Recall Campaign 15V-450: Side Impact Performance

F56 (MINI Cooper S Hardtop 2-Door)

Model Year 2014

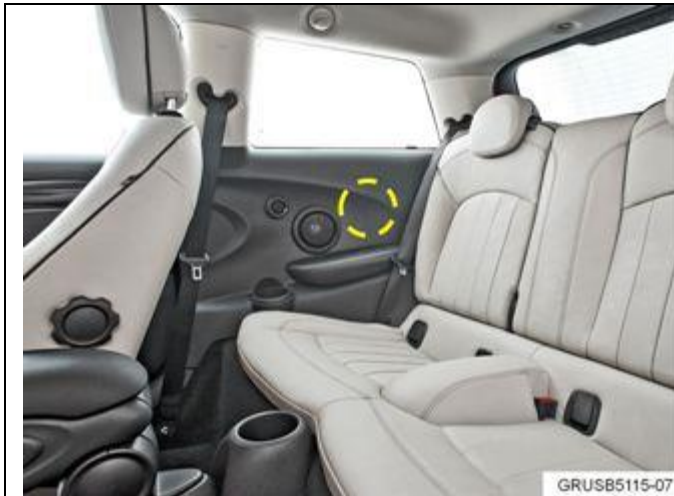
The space between the rear seat left and right interior side panels, and the vehicle body will be modified to increase energy-absorbing performance by installing small structural filler, referred to as a "patch." This modification is not visible to occupants inside or outside the vehicle.

- The general area of the repair is circled, with the side panel in position. The passenger side of the vehicle is shown; the driver side is also affected.
- Remove the rear right and left hand side trim panels per Repair Instructions 51 43 002.

- Clean the area where the patch will be installed.
- Install the self-adhesive foam rubber (patch) to both left and rear panels as indicated by the arrow.
- Install both the rear right and left hand side trim panels per Repair Instructions 51 43 002.
